Grandview Reserve Phase 2 Preliminary Drainage Report

March 2024

EDARP Filing No.:

PUDSP236

DETENTION BASIN OUTLET STRUCTURE DESIGN

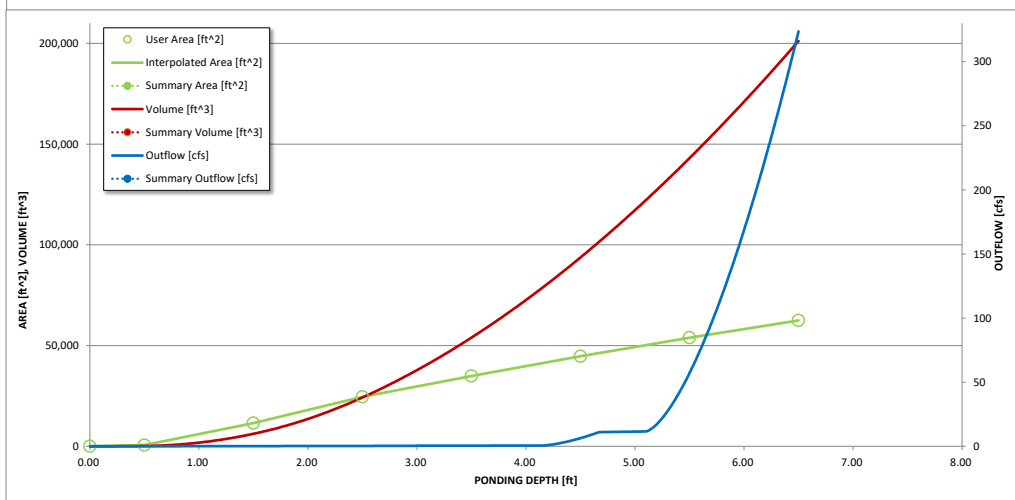
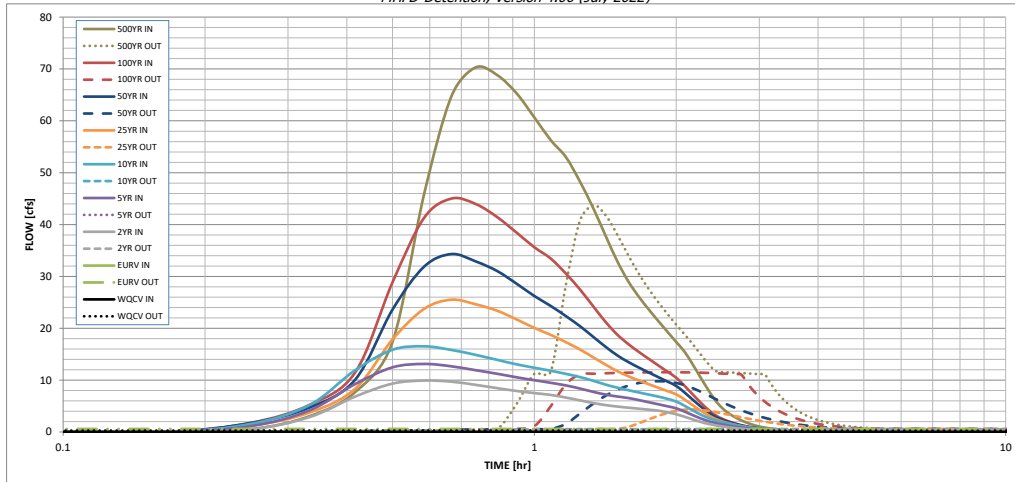
Regardless, your V1 comment responses state that per our conversation you will "not be required to meet pre-development flows for storms between the 5-yr and 100-yr." Which is true. However, the 5-yr ratio for both ponds is still >1. Please address.

DETENTION BASIN OUTLET STRUCTURE DESIGN

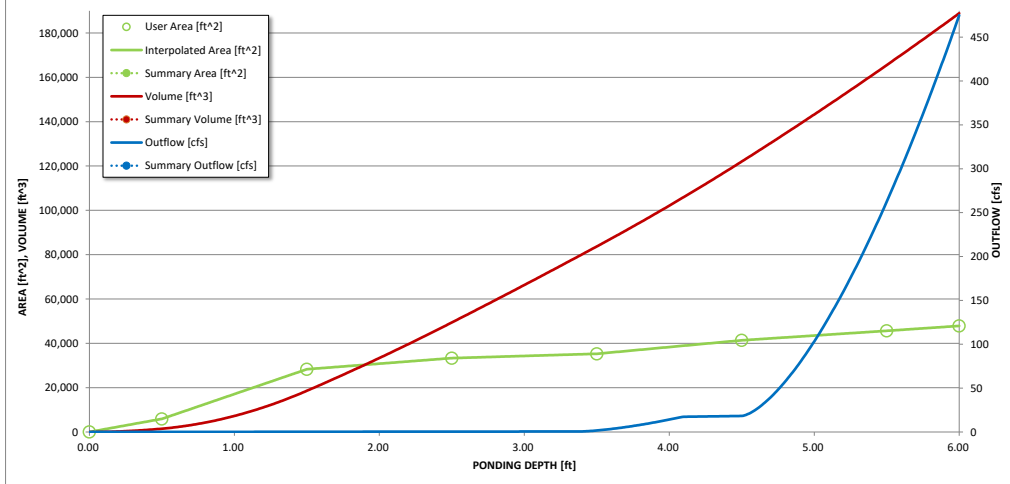
Regardless, your V1 comment responses state that per our conversation you will "not be required to meet pre-development flows for storms between the 5-yr and 100-yr." Which is true. However, the 5-yr ratio for both ponds is still >1. Please address.

PROPOSED DR1

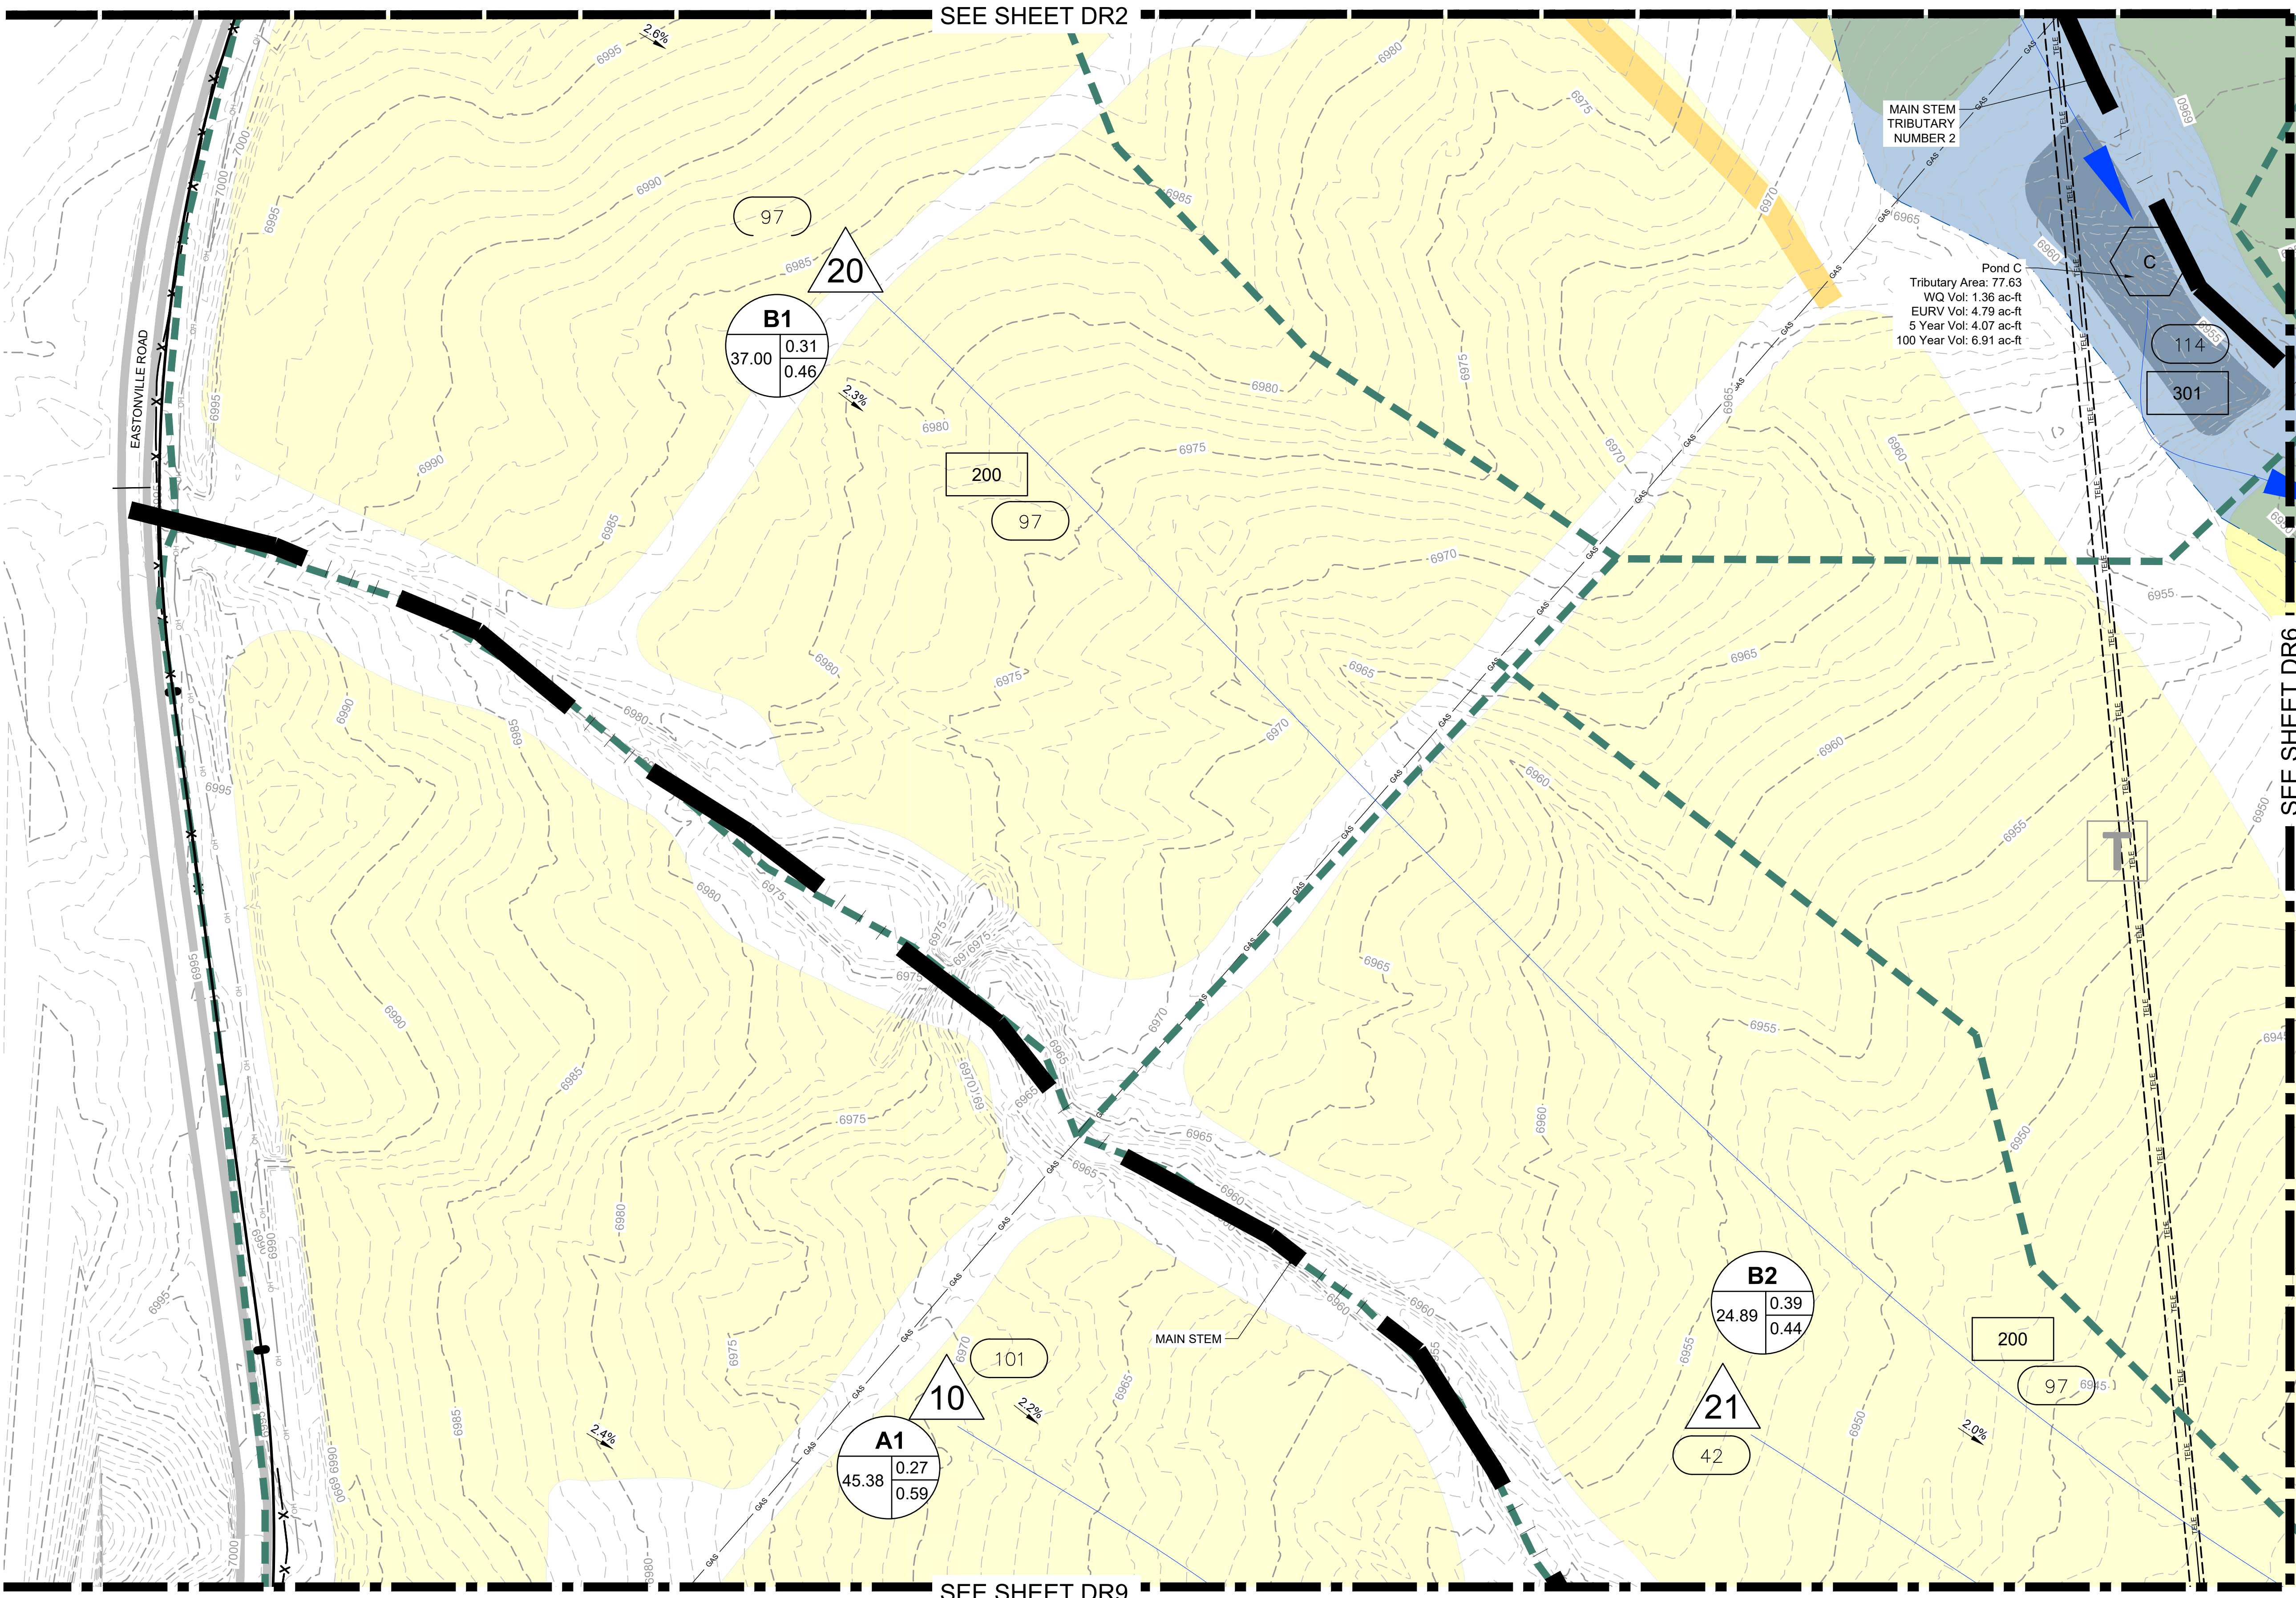
Unresolved comment from Review #1:
Is this Land Use legend supposed to be in color for the colors (like yellow and orange) shown on this map? Either way, please provide a Legend for all of the shaded colors show on these maps.

EXISTING EX1

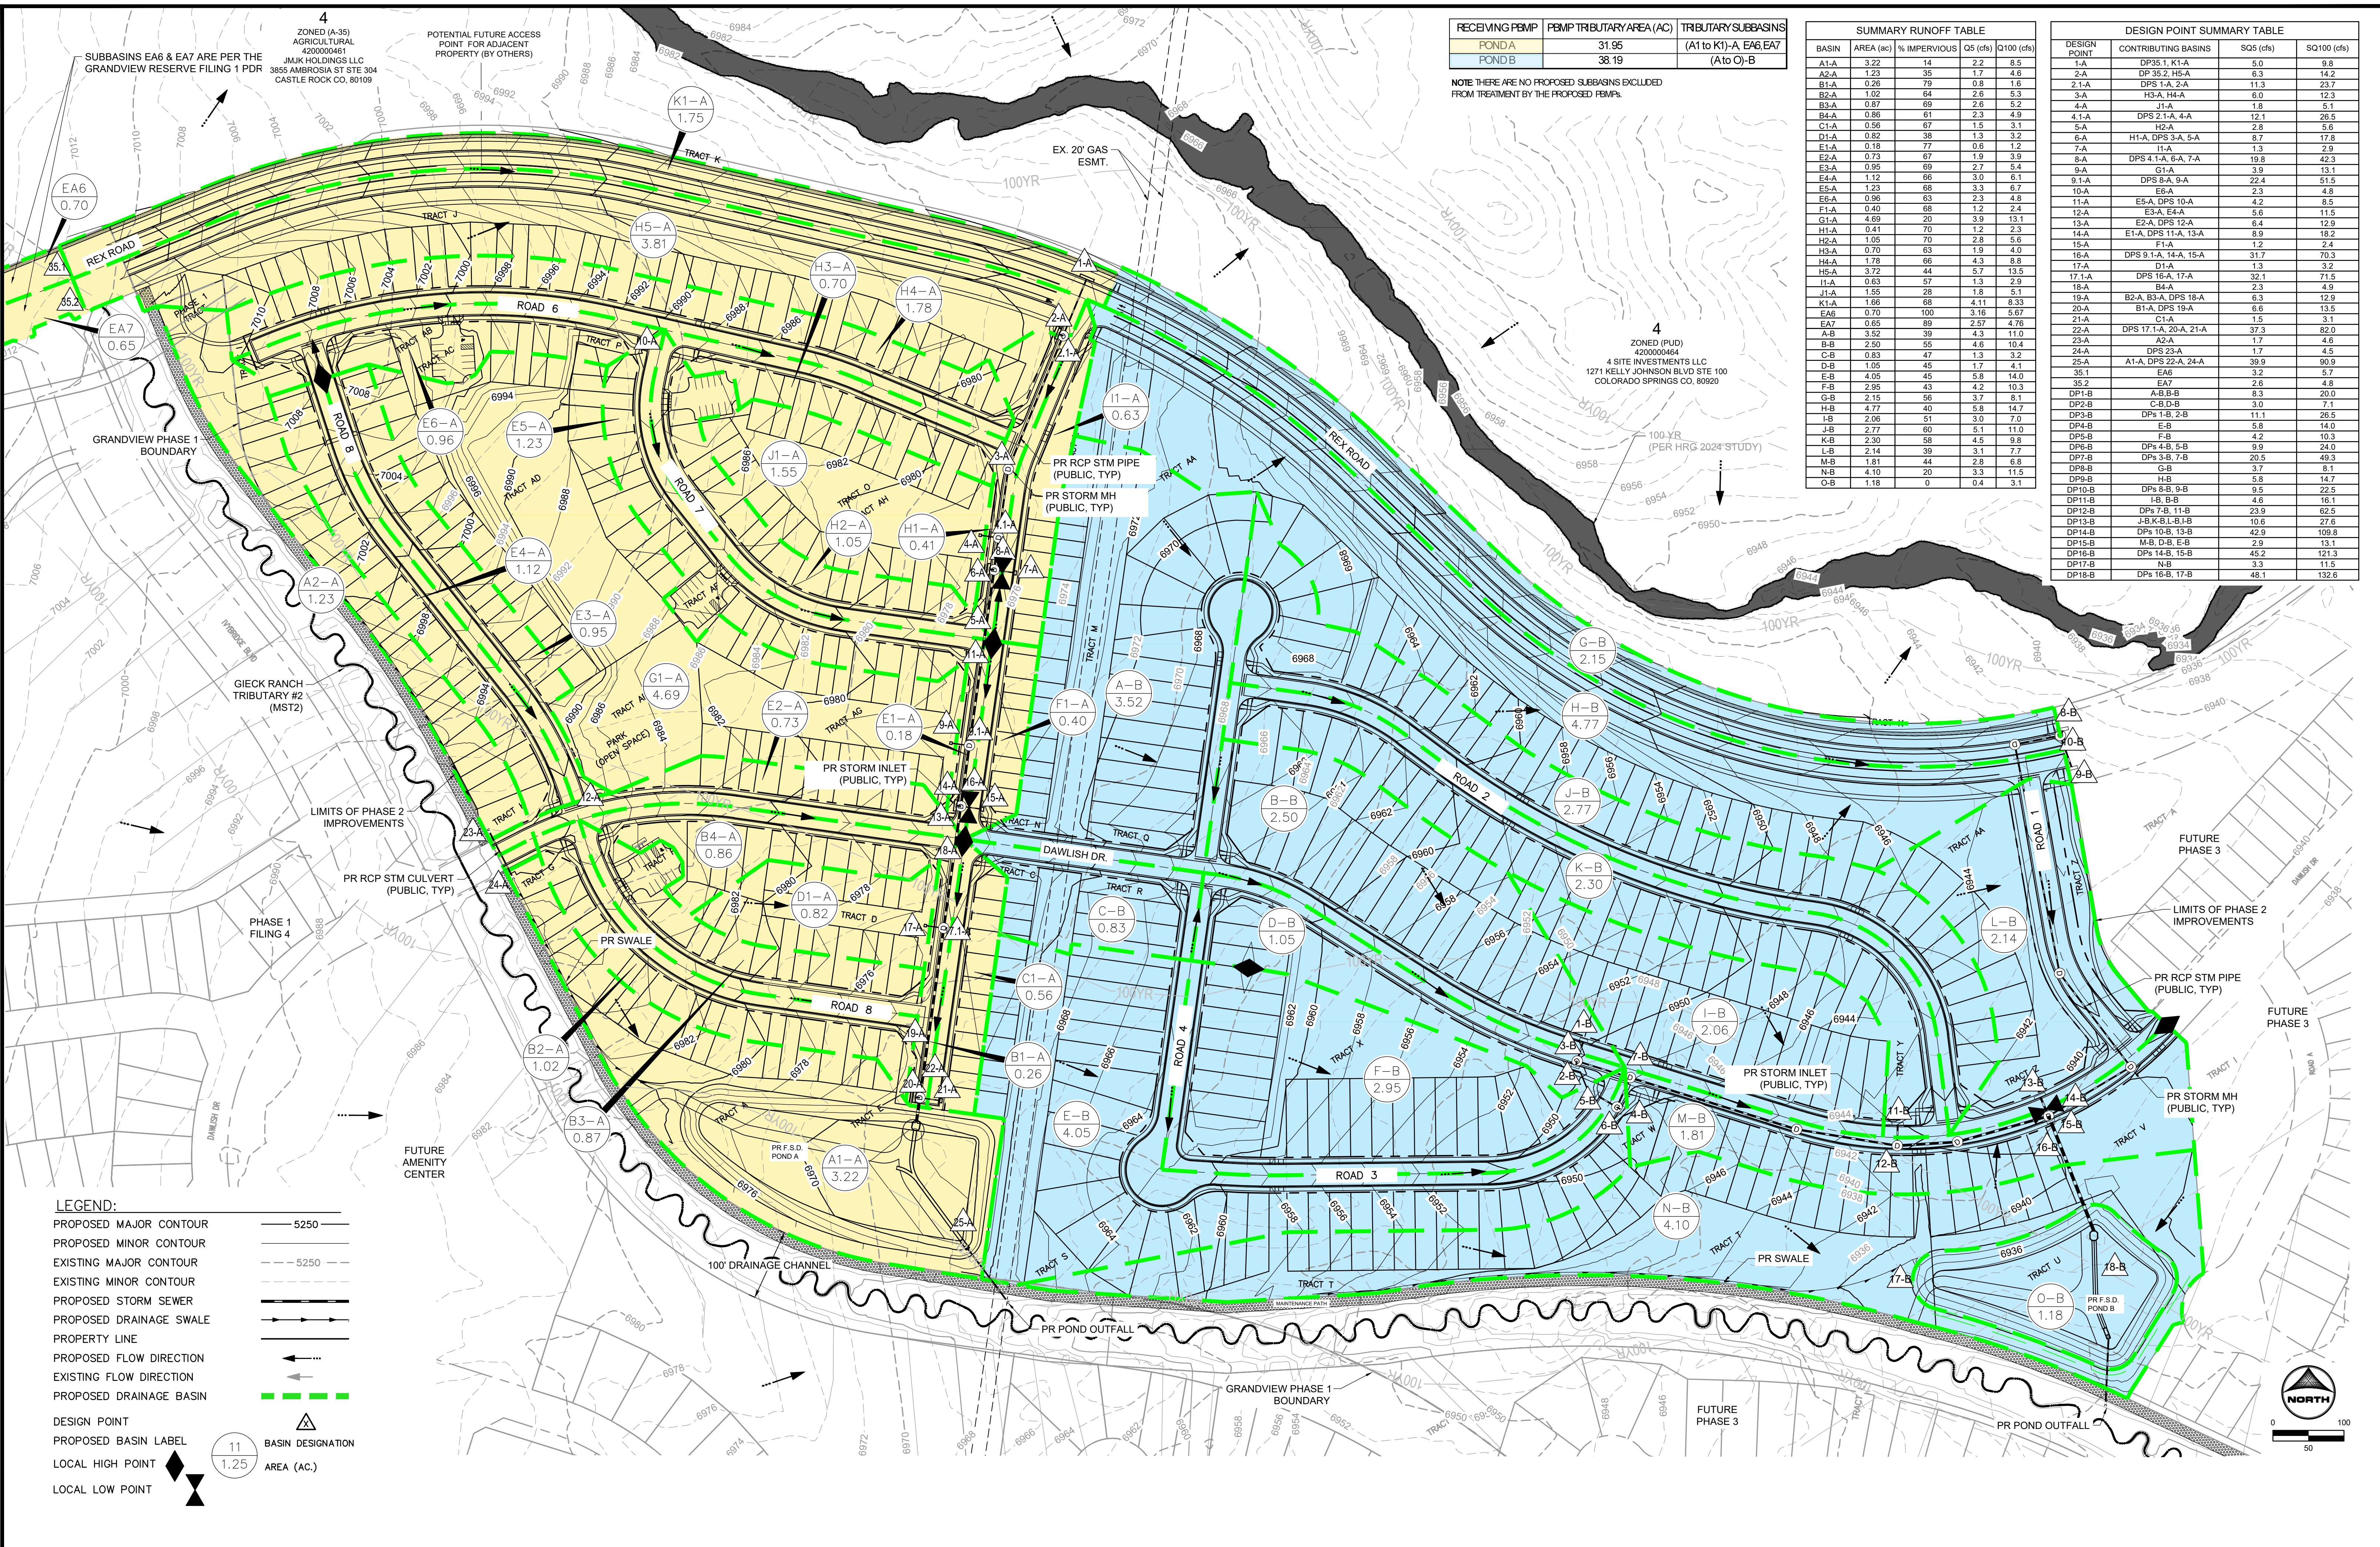
Provide an existing drainage map, specifically for Phase 2. Include design points that will correspond to pond release locations, so historic flows can be compared to pond release rates.
